SUBJECT: Historic Area Work Permit #1104437 REVISION 3– Revision to previous approval, alterations to hardscaping and construction of retaining wall

Previous revisions to the approval were approved by staff on June 24, 2025 and July 23, 2025. The attached revisions provide additional documentation at the southeast corner of the proposed / approved driveway as required by DPS, given the height differential between the approved driveway elevation and adjacent finished grade.

# WILLIAMS LANE RENOVATION

3806 Williams Lane, Chevy Chase, MD 20815 - Project # 2462

## ZONING SITE PLAN

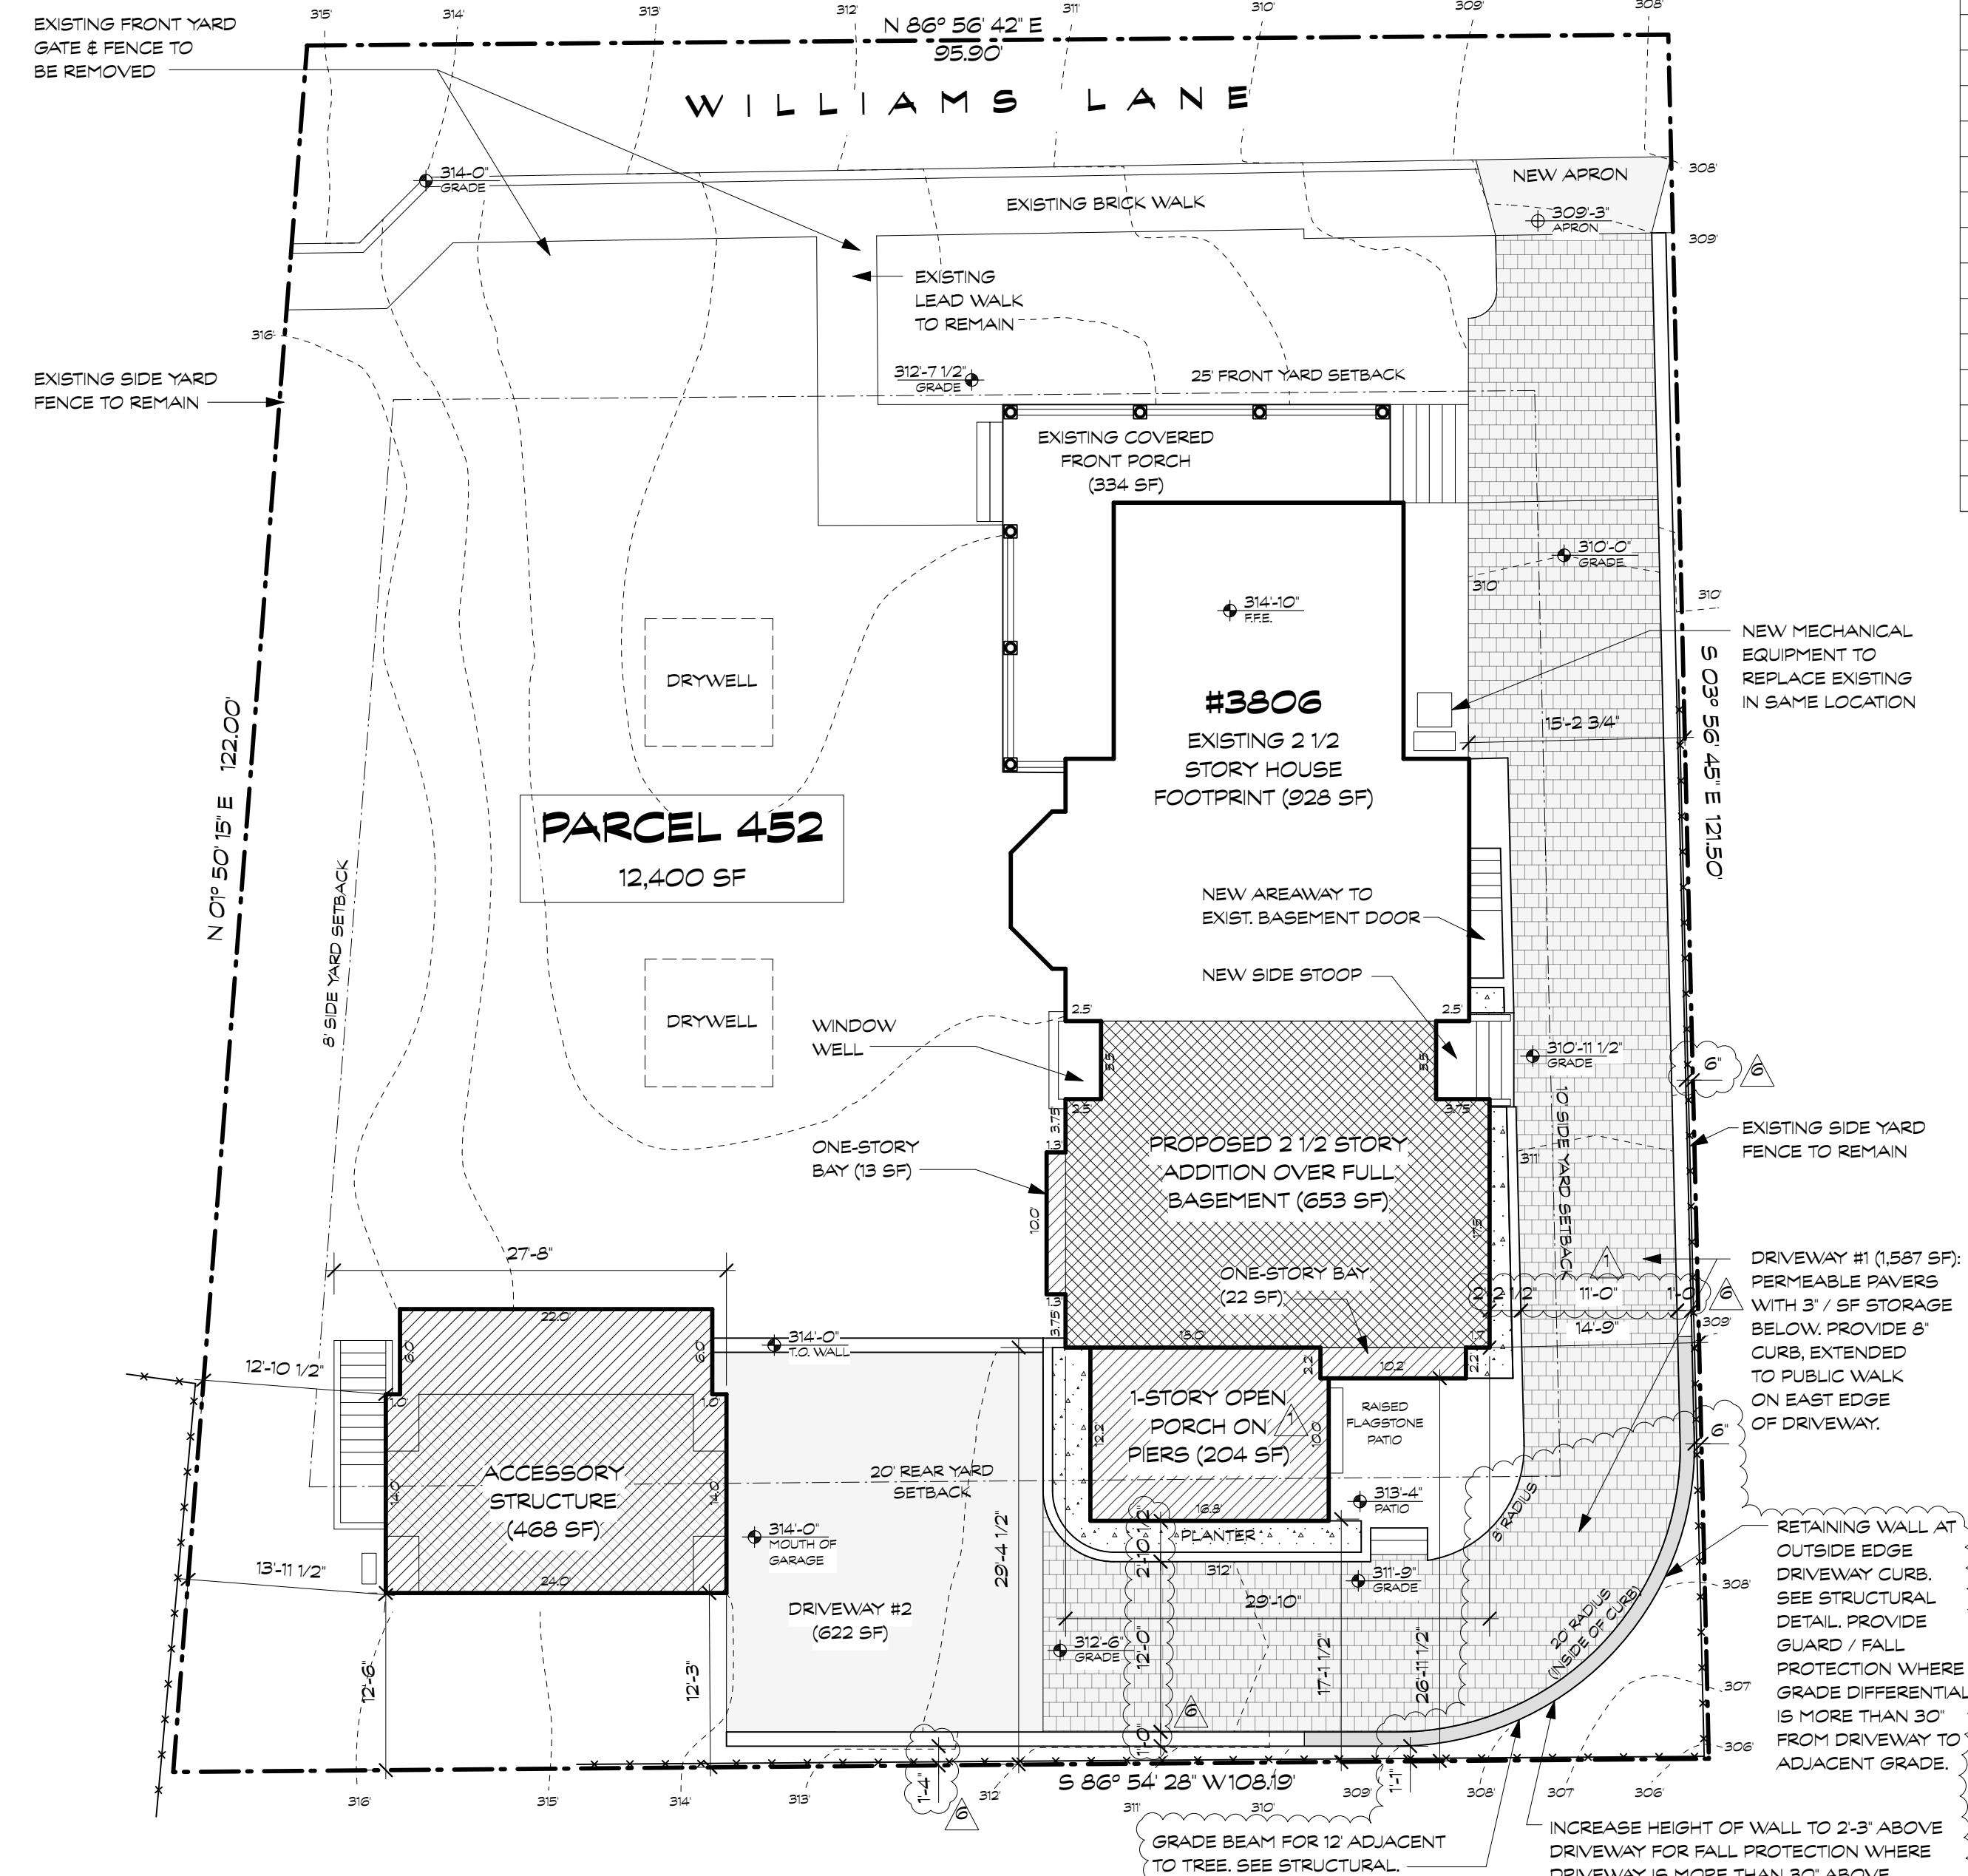
PERMIT REVISION: DRIVEWAY WALL, AS SHOWN ON PREVIOUSLY APPROVED SITE PLAN, HAS BEEN REDESIGNED TO BE A RETAINING WALL.
